# **Safety Evaluation Report** for an Early Site Permit (ESP) at the Grand Gulf ESP Site

Docket Nos. 52-009

**U.S. Nuclear Regulatory Commission  
Office of Nuclear Reactor Regulation  
Washington, DC 20555-0001**

**Figure 2.4-5 Grand Gulf ESP site vicinity map**

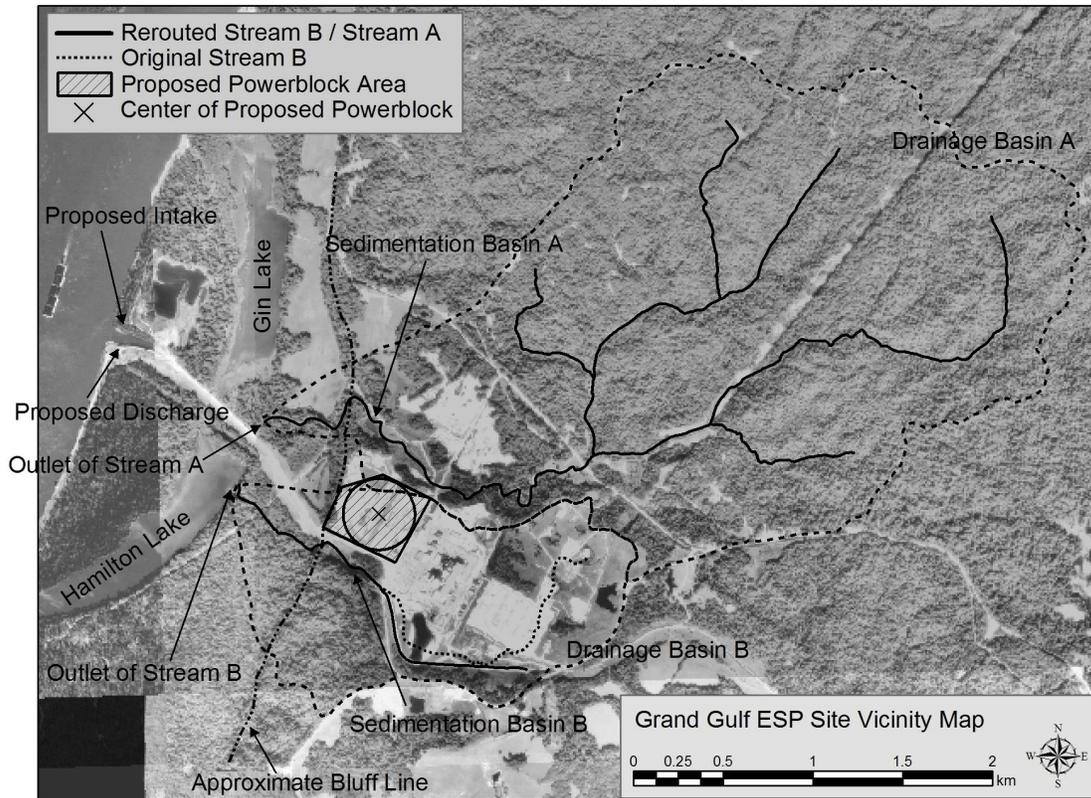
The staff's review of SSAR Figures 2.1-1 and 2.1-2 revealed that, although the coordinates inscribed on these figures for the center of the proposed powerblock are the same as those mentioned in applicant's response to RAI 2.4.1-1, the coordinates do not agree accurately with the position of the center of the proposed powerblock as drawn on these figures. The staff independently created a map to more accurately locate the center of the proposed powerblock. Figure 2.4-5 shows this map.

The map shown in Figure 2.4-5 uses the UTM Zone 15N North American Datum (NAD) 1983 geographic projection. As shown on SSAR Figures 2.1-1 and 2.1-2, the applicant's PPBA is located north of the heavy haul road, east of the bluffs, and southeast of the ESC building. The staff created the polygon labeled "Proposed Powerblock Area" on Figure 2.4-5 closely following the location of applicant's PPBA shown on SSAR Figures 2.1-1 and 2.1-2. The staff overlaid the largest circle that could fit inside the PPBA as shown in Figure 2.4-5. The staff assumed that the center of this circle represents the location of the center of the proposed powerblock. The UTM coordinates determined by the staff for the center of the proposed powerblock are N3,543,266.06 meters and E684,017.28 meters, with reference to the UTM Zone 15N NAD 1983 geographic projection.

The staff also overlaid the applicant-stated coordinates of the center of the proposed powerblock on the map and found that these coordinates place the proposed powerblock approximately 302 feet southwest of the staff-estimated coordinates mentioned above and closer to Stream B. Because of this discrepancy between the coordinates provided by the applicant and the plotted location of the powerblock on Figures 2.1-1 and 2.1-2, the staff cannot determine the actual location of the powerblock on the ESP site. Therefore, the staff required additional information on the true coordinates of the center of the powerblock. This was Open Item 2.4-1. The staff intended to specify the coordinates of the center of the proposed powerblock as a permit condition subsequent to the satisfactory resolution of Open Item 2.4-1.

In response to Open Item 2.4-1 (Response to Request for Additional Information to Resolve the Grand Gulf Early Site Permit draft Safety Evaluation Report Open Items, System Energy Resources, Inc., June 21, 2005), the applicant stated that the UTM coordinates indicated in the SSAR, ER, and Environmental Policy Institute documents were inaccurate because of an error in a spreadsheet which was used to calculate UTM coordinates corresponding to Mississippi West grid coordinates. The applicant converted the coordinates of the center of the ESP powerblock, N550,099 feet and E277,346 feet in the Mississippi West grid coordinate system, to N3,543,261 meters and E684,018 meters in the UTM Zone 18 NAD 83 projection system using USACE software Corpscon Version 6.0. The applicant revised Figures 2.1-1, 2.1-2, 2.2-4, 2.4-1, 2.4-10, and 2.4-33 of the SSAR. The applicant also revised SSAR Sections 1.2, 2.1.1.1, and 2.4.1.1; Part 1, "Administrative Information," in Section 1.1; Part 4, "Emergency Planning Information," and Figures 2-1 and 2-3; and Section 2.1.1, ER Figures 2.1-1, 2.2-1, 2.3-1, 2.3-7, 2.3-12, and 2.3-20; and ER Sections 1.1, 2.1, 2.3, and 4.5.1 to include corrected UTM coordinates.

**Figure 2.4-8 Simplified cross-section of the Mississippi River near the ESP site (not drawn to scale)**

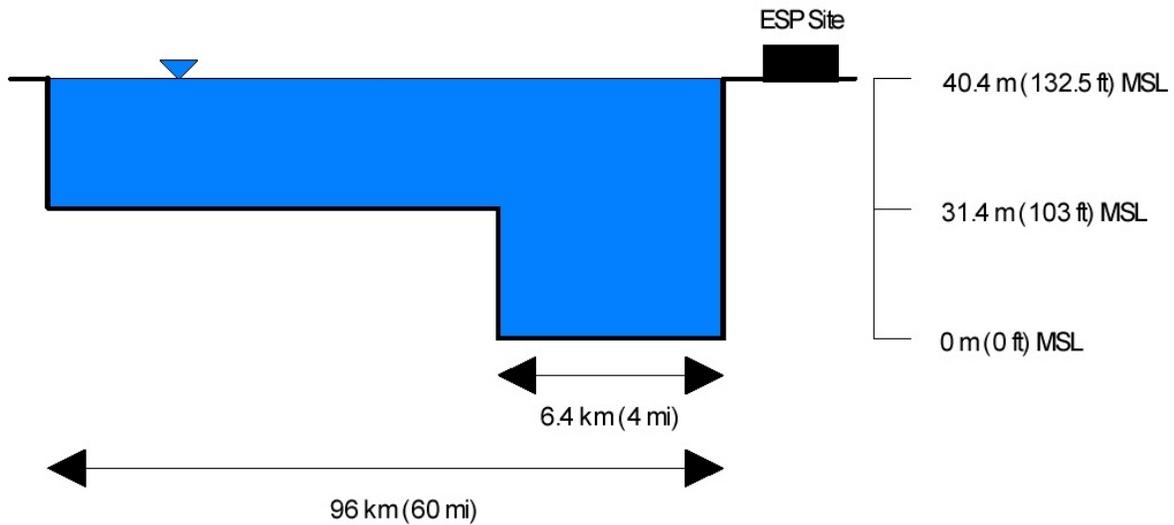
The staff carried out a simplified bracketing estimation of the discharge needed to raise the water surface elevation near the GGNS site above the existing GGNS Unit 1 plant grade of 132.5 feet above MSL. The staff assumed a simplified cross-section for the Mississippi River near the GGNS site, as shown in Figure 2.4-8. The staff conservatively assumed that the width of the floodplain is 60 miles, even at a water surface elevation of 132.5 feet above MSL. The cross-sectional area of discharge is estimated as 11.5 million square feet (ft<sup>2</sup>). The wetted perimeter was estimated as 317,065 feet.

Based on a staff-assumed Manning's roughness coefficient of 0.025 for natural channels and a bed slope of 0.2 feet per mile (ft/mi), the staff estimated the discharge in the Mississippi River corresponding to a water surface elevation of 132.5 feet above MSL as 46.3 million cfs. This estimate is more than four times larger than the discharge capacity of the river at a water surface elevation of 103 feet above MSL, and about seven times larger than the applicant-estimated PMF. Therefore, the staff concluded that the ESP site is safe from flooding caused by a seismically induced dam failure upstream of the GGNS site.

**Figure 2.4-10 Minimum daily average streamflow in the USGS record for all water years 1932–1998 at Vicksburg, Mississippi. Red circles with years show six lowest historical values.**

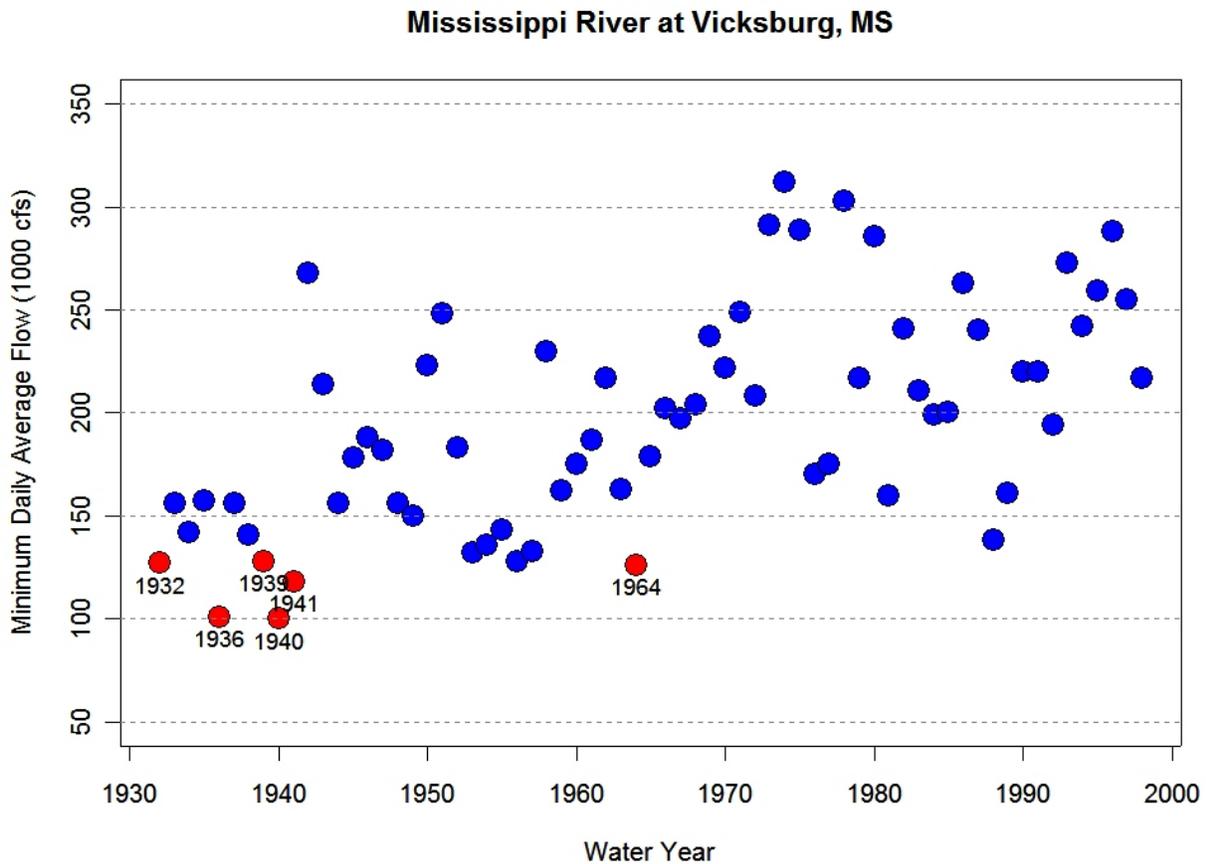
Using the USGS "National Water Information System," the staff reviewed low-water conditions based on daily streamflow records at the Vicksburg Gauging Station. Figure 2.4-10 shows the minimum daily streamflow observed at Vicksburg, Mississippi, during water years 1932–1998 as 100,000 cfs on November 1, 1939. Apparently, the applicant mistyped the date for this same streamflow as November 1, 1940, in the ESP application. According to the USACE report, "Stages and Discharges of the Mississippi River and Tributaries in the Vicksburg District,

Figure 2.5.4-5 (Updated final version of SSAR Figure 2.5-87) Shear Modulus Reduction Curves For Loess

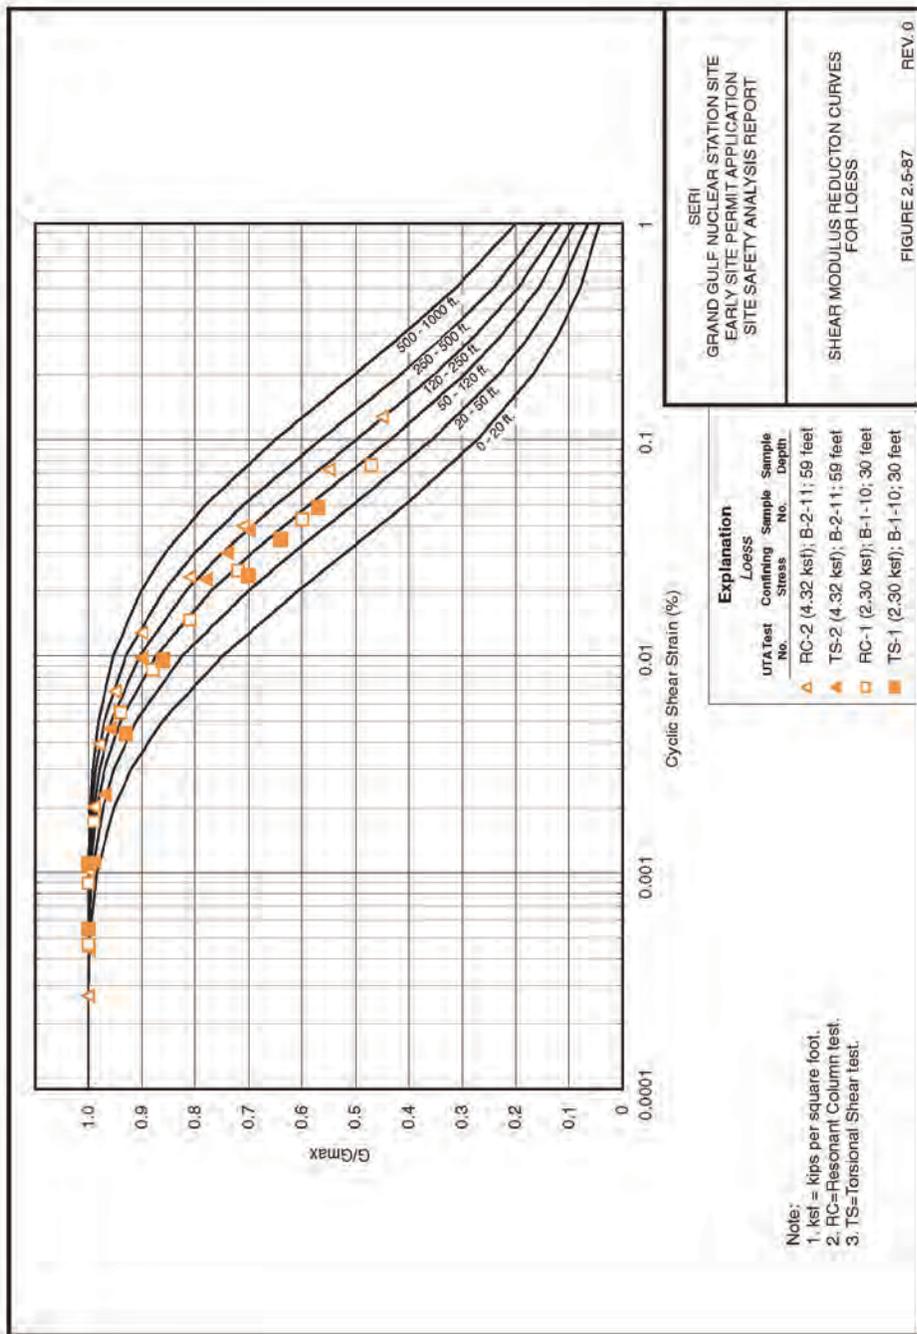
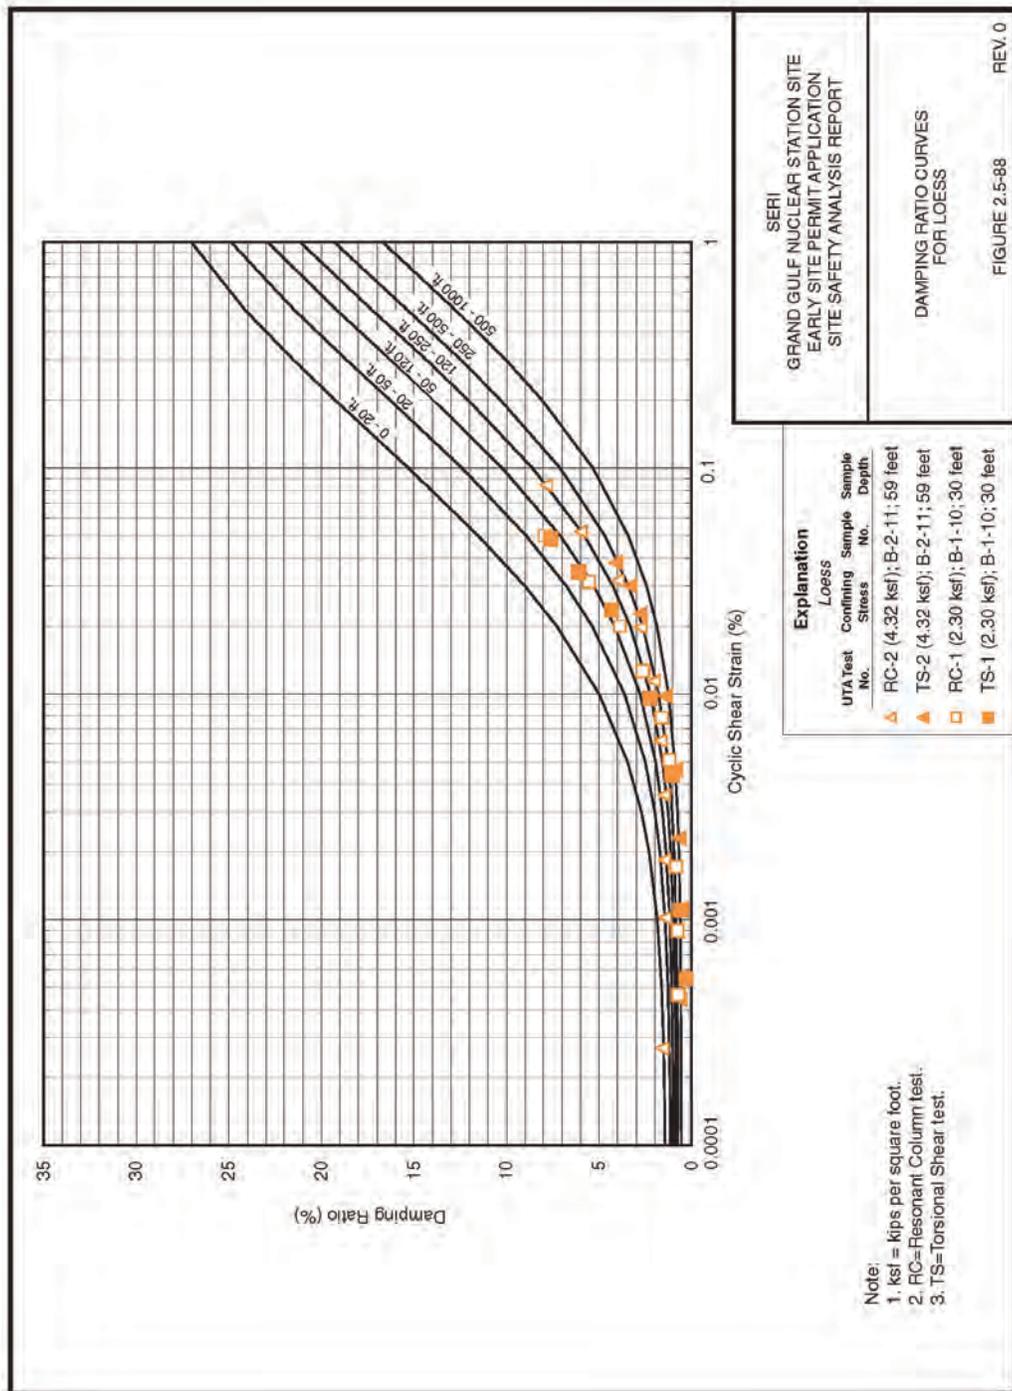
In RAI 2.5.4-7, the staff asked the applicant to provide its rationale for not incorporating these effects in the site response calculations and to evaluate the potential impact of these modifications on the computed surface UHRS. In its response, the applicant referred to its response to RAI 2.5.4-6 and stated that the analysis and selection of the appropriate EPRI-TR curves for shear modulus reduction and hysteretic damping fully account for the effects of possible disturbance to the test specimens resulting from stress release during sampling, as well as possible movements during testing. The applicant considered the effects of sample relaxation by examining the results from testing soils at both the estimated in situ confining stress and 4 times the estimated in situ confining stress. The applicant plotted these two data sets together on the EPRI-TR base curves as shown in Figures 2.5.4-5 through 2.5.4-12, which replicate SSAR Figures 2.5.4-87 to 2.5.4-94. The two data sets were weighted to select the most representative EPRI-TR curve.

**Figure 2.5.4-13 (Figure 2.5.4-4-1 of the RAI response)  
Deep Profiles for Sensitivity Analyses**

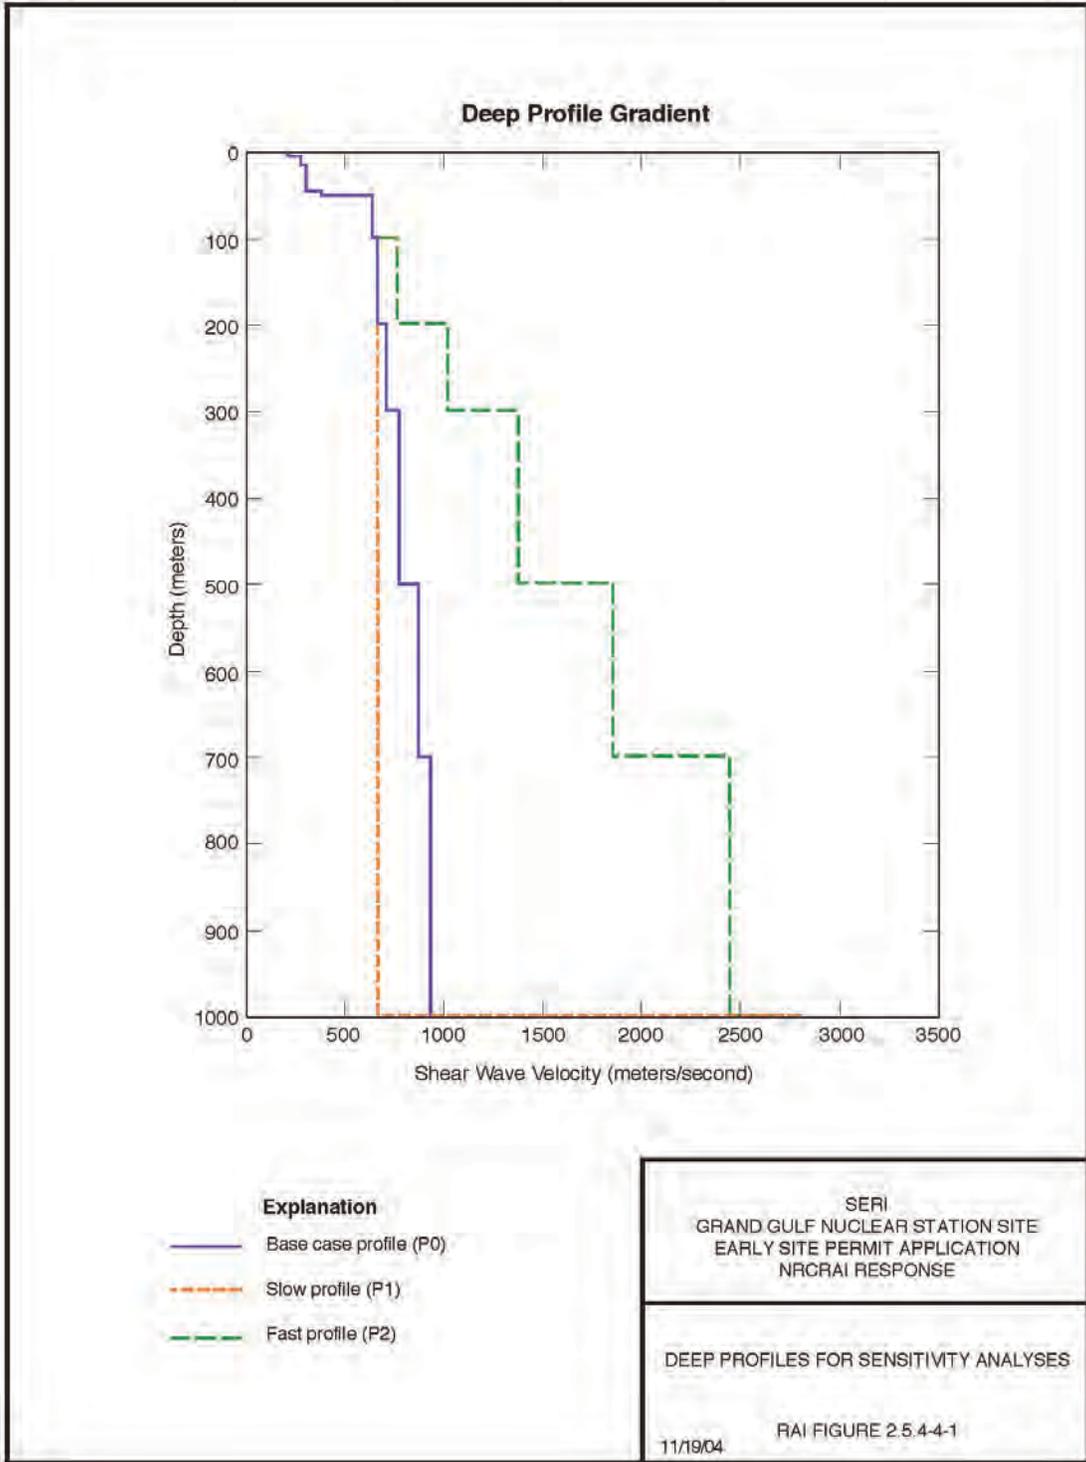
Figure 2.5.4-13 shows the base case shear wave velocity profile to the analysis depth of 1 kilometer along with two extreme cases for extrapolation to the hard rock shear wave velocity of 2.8 km/s. The slow profile assumes a uniform extension of the velocity just beneath the site to 1 kilometer, with a jump to the hard rock value of 2.8 km/s. As another extreme alternative, the fast profile assumes a linear (modeled as a stair step) gradient with depth, reaching 2.8 km/s at a depth of 1 kilometer. Based on general experience with measured shear wave velocity profiles in large sedimentary basins, the applicant expected the slow and fast profiles to reflect extreme (i.e., low likelihood) conditions, particularly with regard to the local and regional overall geology.

The staff also asked the applicant to compare the values of shear wave velocity to the BE, UB, and LB values used in the site response calculations. In its response, the applicant stated that Figure 2.5.2-4, which replicates SSAR Figure 2.5-60, presents the BE velocity profile adopted for the site soil response analysis. This velocity profile is based on a visual average of the composite P-S velocity profiles from the three ESP boreholes. It is an averaged, smoothed profile that does not use extreme values. The BE profile consists of five separate interval velocities that incorporate velocity data that were binned differently than the various general and estimated velocity ranges described for different stratigraphic units. The BE interval velocities of the site soil response velocity profile are not set at stratigraphic unit boundaries but rather are assigned at visually determined velocity breaks in the composite P-S profile. For this reason, the BE site soil response average velocities are not centered on the mean values listed for soil layers in ER-02 Table 8.2.

To compare the median motions computed for the three profiles, the applicant stated that it used the 1- to 2-Hz-scaled  $10^{-5}$  APE spectrum as the control motions to excite the column at low as well as high frequency since it is quite similar to the UHRS and sufficiently broad band (i.e., large magnitude) compared to the UHRS. Figures 2.5.4-14 and 2.5.4-15 show the resulting soil median motions in both the logarithmic and linear spectral axes, respectively. As expected, little difference exists between the motions computed for the three profiles from 0.3 to 100 Hz. At peak acceleration, the fast and slow profiles show about a 5-percent increase and decrease, respectively, in motions, as compared to the base case profile. The motions reflecting the fast profile generally exceed those of the base case by about 5 percent. The largest exceedance is near a resonance at about 3 Hz, at which the fast profile motions exceed the base case motions by about 10 percent. Based on regional geology as well as experience with similar geology in deep basins, this fast profile is extremely unlikely and would receive very low weight in a hazard analysis. The applicant stated that these site response analyses illustrate the general insensitivity of the motions to the nature of velocity gradients likely to exist in the deep materials beneath the site.
